THE AURORA HIGHLANDS SUBDIVISION FILING NO. 33
A RESUBDIVISION OF A PORTION OF TRACT E, THE AURORA HIGHLANDS SUBDIVISION FILING NO. 1
SITUATED IN THE SOUTHEAST QUARTER OF SECTION 30, TOWNSHIP 3 SOUTH, RANGE 65 WEST OF THE SIXTH PRINCIPAL MERIDIAN,
CITY OF AURORA, COUNTY OF ADAMS, STATE OF COLORADO
SHEET 2 OF 13

THE AURORA HIGHLANDS SUBDIVISION FILING NO. 33

Re: Initial Submission Review: The Aurora Highlands Lennar Phase 1 Site Plan - Site Plan and Plat
Application Number: DA-2062-61
Case Numbers: 2024-4018-00; 2024-3038-00

A RESUBDIVISION OF A PORTION OF TRACT E, THE AURORA HIGHLANDS SUBDIVISION FILING NO. 1
SITUATED IN THE SOUTHEAST QUARTER OF SECTION 30, TOWNSHIP 3 SOUTH, RANGE 65 WEST OF THE SIXTH PRINCIPAL MERIDIAN,
CITY OF AURORA, COUNTY OF ADAMS, STATE OF COLORADO
SHEET 4 OF 13

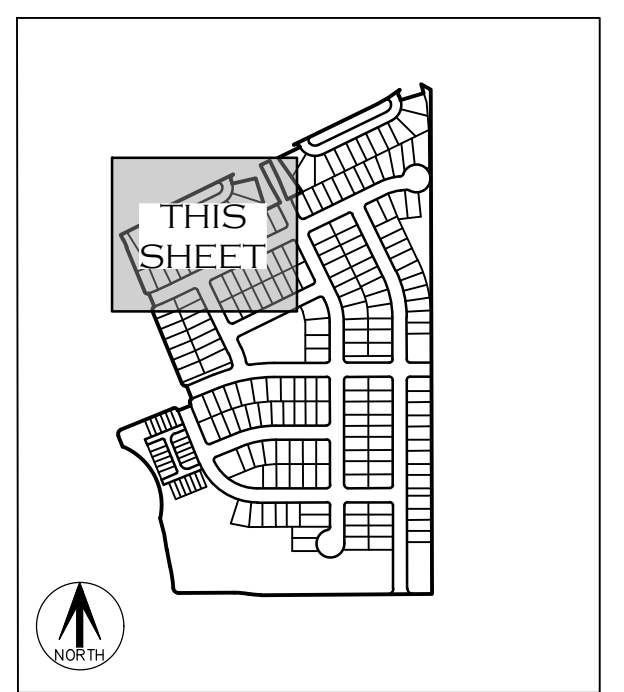
Confirm that easement names match
between the site plan and plat.
(Typical)

Site Plan calls for
existing U.E.?

Site Plan shows a
proposed drainage
easement?

Site Plan shows 29th?

Site Plan shows a
existing drainage
easement?

We are not in control of
what is shown on the
site plan. We send a
CAD base to the
engineer and they
need to make sure it
matches the Plat.

These are not a drainage
easement of record within the
title commitment, so I believe
these easements were never
dedicated by separate document.

Note Added
to Legend

A RESUBDIVISION OF A PORTION OF TRACT E, THE AURORA HIGHLANDS SUBDIVISION FILING NO. 1
SITUATED IN THE CITY OF AURORA, COUNTY OF ADAMS, STATE OF COLORADO
SHEET 12 OF 13 SEE SHEET 6

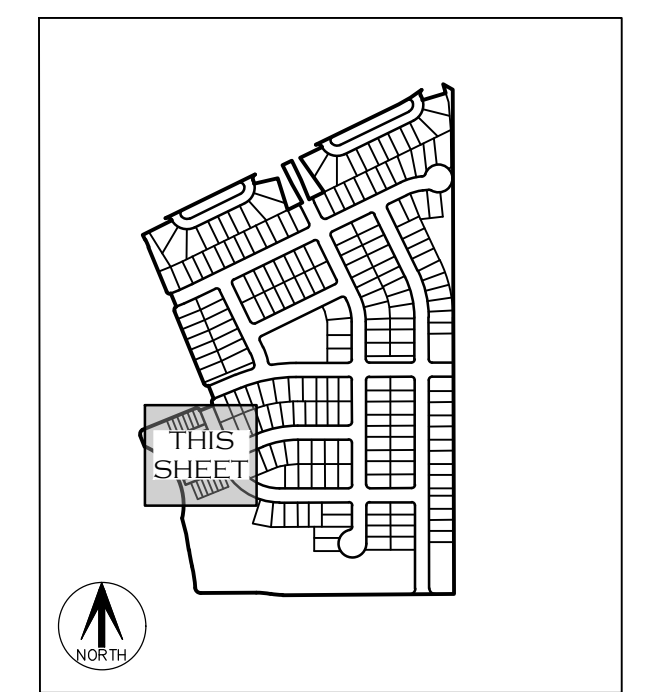
Site Plan calls for Drainage, Utility, & Access?

Site Plan calls for 23' F.L.E.?

U.E. on site plan?

Label Easement?

Extended to match into 10' UE

Revised to 10' wide UE

Note Added to Legend
